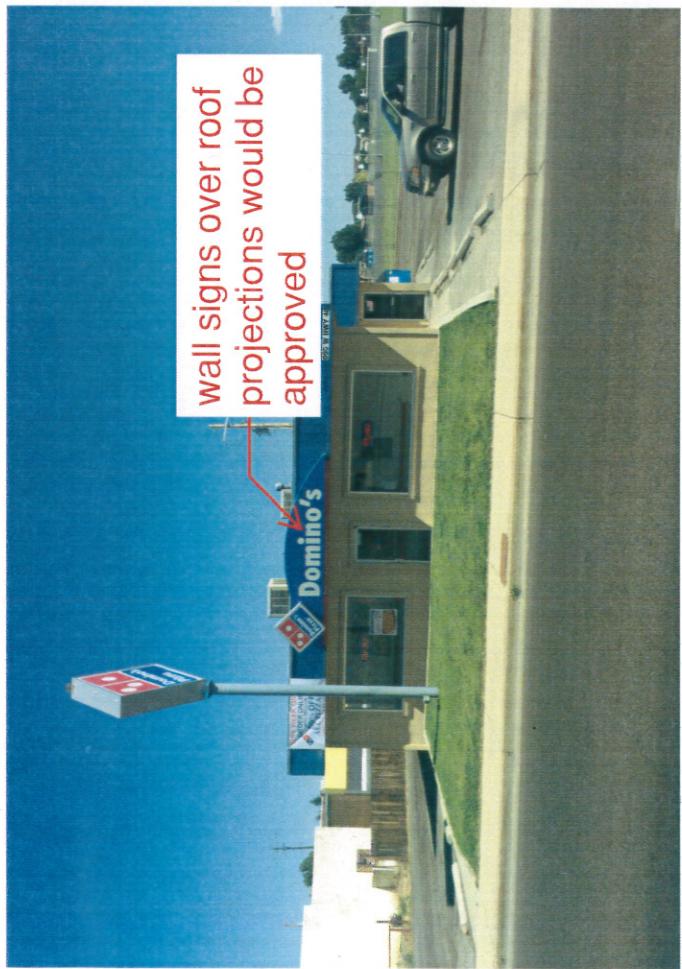
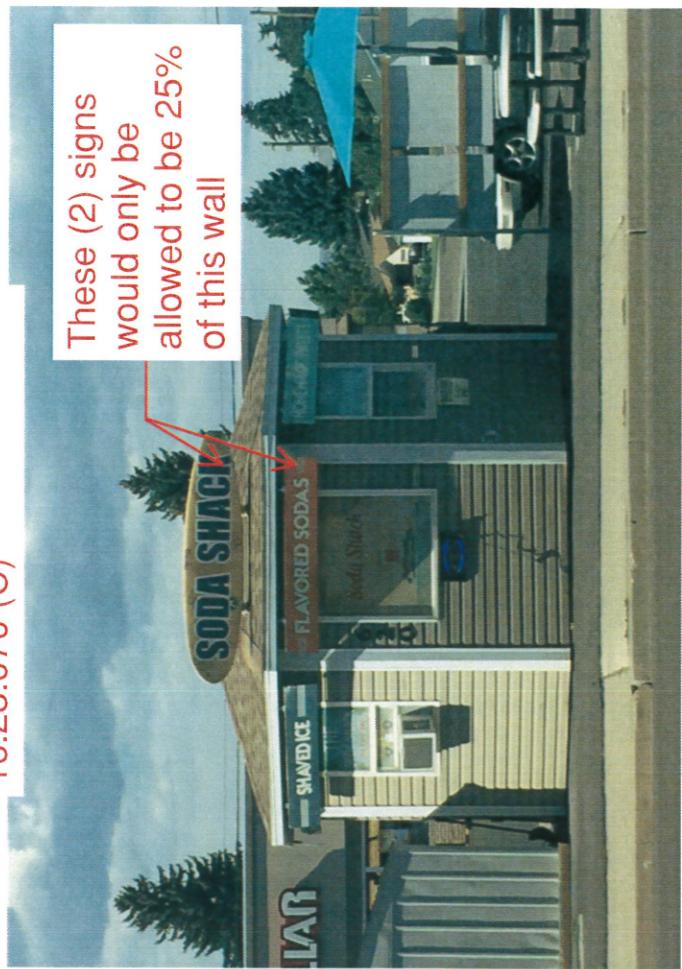
Roof and Wall signs combined would only be allowed to be 150 square feet in this case as per new code 16.28.070 (C)

unregulated signage?
